## CANBY PLANNING COMMISSION

City Council Chambers  
Monday, July 11, 1994  
7:30 p.m.

# **- STAFF REPORT -**

DR 94-09

**LANDSCAPE PLAN**

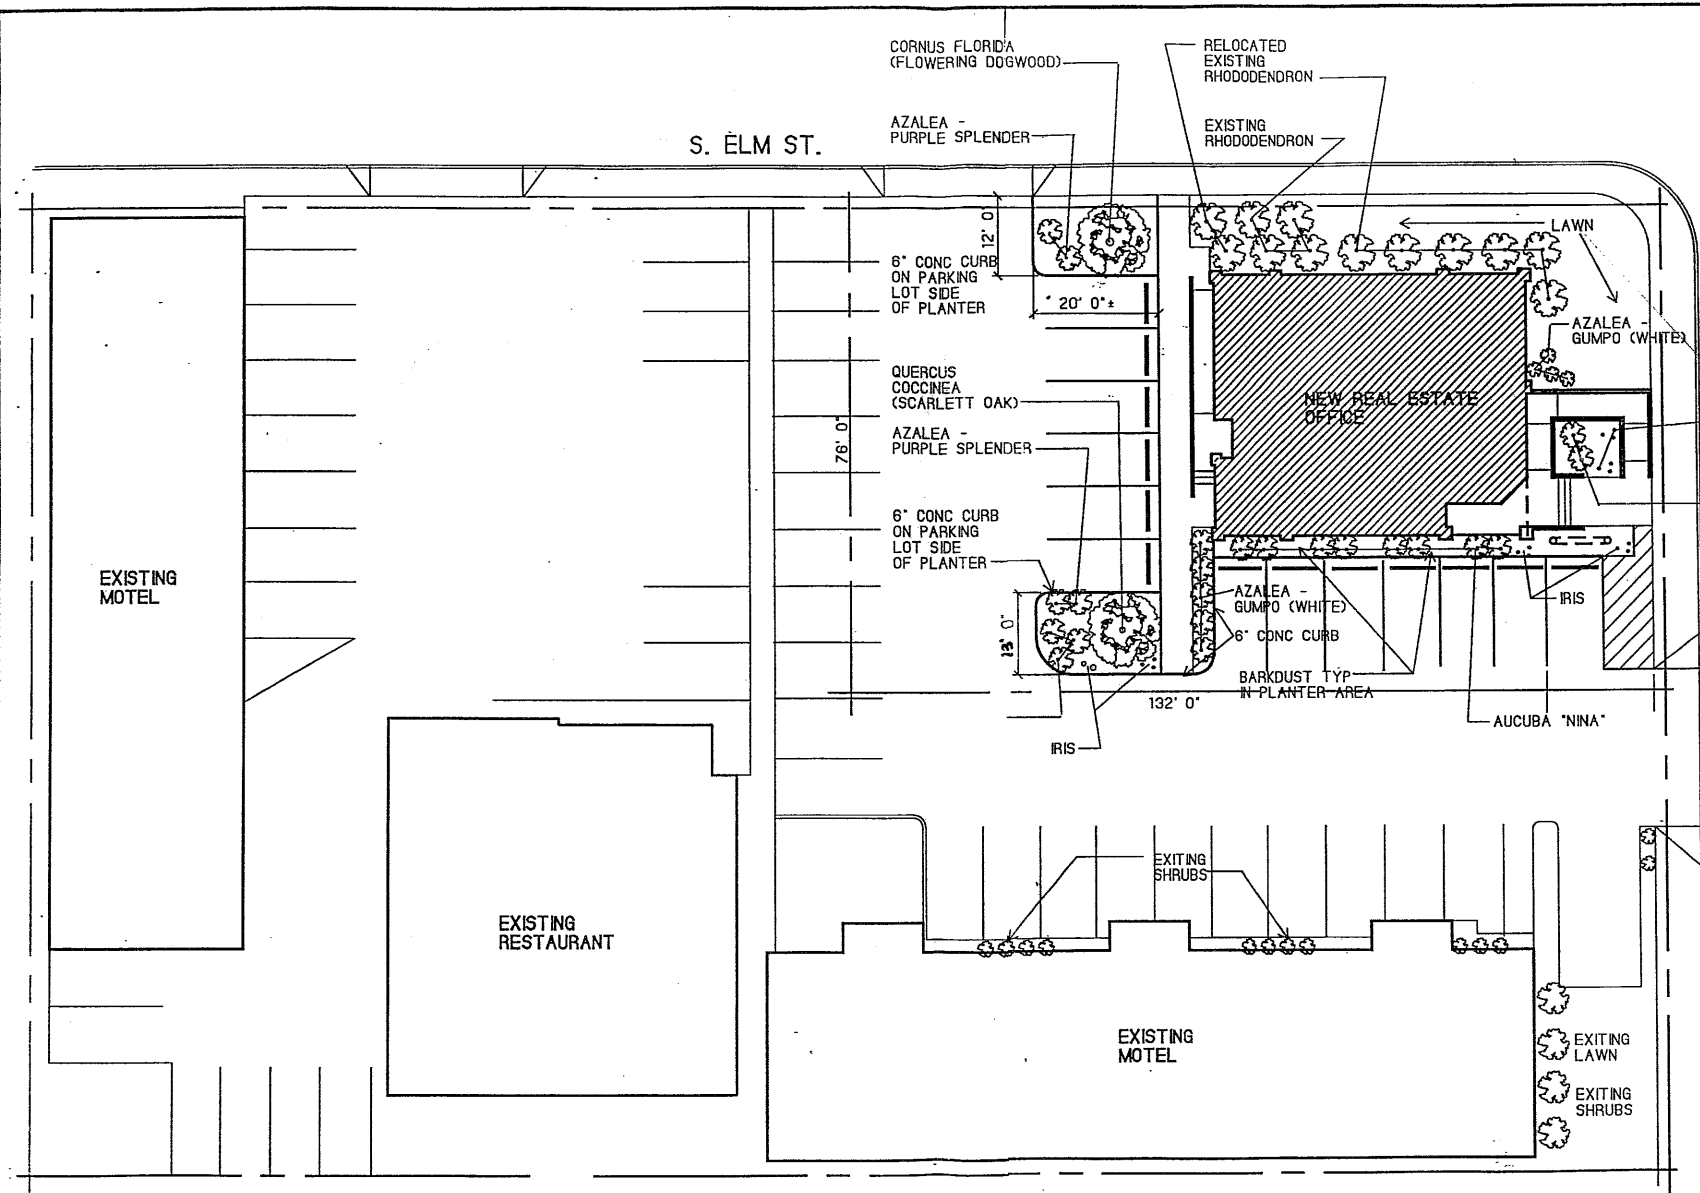
The eastern parking lot landscape island will be landscaped with a scarlett oak, azaleas, and irises. The western parking lot landscape island will be landscaped with a flowering dogwood and azaleas.

The amount of paved area for parking and vehicle maneuvering area is approximately 4,950 square feet. The amount of landscaping required for that amount of area is 743 square feet, and is to be within ten feet of the parking/maneuvering area. The amount of landscaping provided within ten feet of the parking/maneuvering area is approximately 788 square feet. At the formula of one tree per 2800 square feet of paved vehicular maneuvering and parking area, a total of 2 trees are needed. There are 2 trees within or adjacent to the paved vehicle parking/maneuvering area. The scarlett oak that is proposed to be planted in the eastern parking lot landscape island will grow to be 40 to 60 feet in height, much larger than specified in Section 16.49.120.6. The section does not specifically mandate that the mature height of trees shall not be higher than 20 to 30 feet. In all other aspects, the proposed tree should be more than adequate for the proposed location.

CUB has some concerns with the choice of the CORNUS Florida (Flowering Dogwood) tree that has been shown located along the Elm Street side of the subject property. This species is known to grow to a 50ft height in the Portland area. CUB has three phases of overhead primary power lines along the East side of South Elm Street at the subject property. The developer should meet with CUB representatives to go over utility requirements and specifications and costs.

1. Approval of the driveway access to State Highway 99-E shall be obtained from the Oregon Department of Transportation, prior to the issuance of the building permit.
2. Storm water design and construction of the paved area of the property shall be approved by the Canby Public Works Department.
3. A detailed landscape plan shall be submitted with the building permit. The detailed landscape plan shall show: the number of plants, plant spacing/location of planting, the type of plants, the schedule of planting, and irrigation plans.
4. The landscaping shall be planted at such a density so as to provide a minimum of 95% coverage of the landscape areas with vegetation, within a 3-year time period. Bark mulch and similar material shall consist of not more than 5% of the total landscape area after the 3-year period.
